Technical Service Bulletin

| MODEL(S) AFFECTED: | Speed Scrub Rider |
| SUBJECT: | Drive motor wires may need to be repositioned to avoid wire abrasion when making right and left hand turns. Inspect the wire harness for clearance and if necessary reposition the wires as described below. |

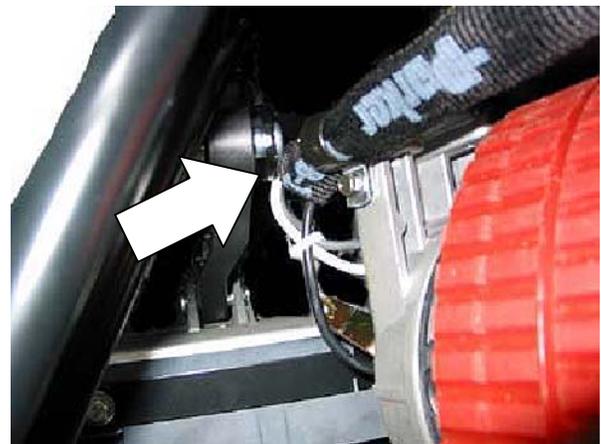
Abrasion point when making a left hand turn. Comes in contact with rotomold edge.

Abrasion point when making a right hand turn. Comes in contact with the scrub head pivot arm.

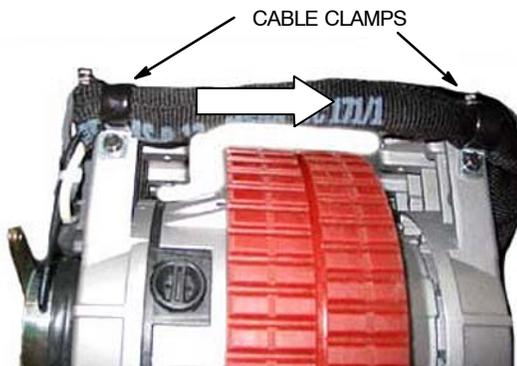
To reposition the wire harness to avoid abrasion:

1. Loosen the two cable clamps and move the wire harness away from the abrasion points. Re-secure clamps.

2. Secure the wires with two wire ties as shown below.
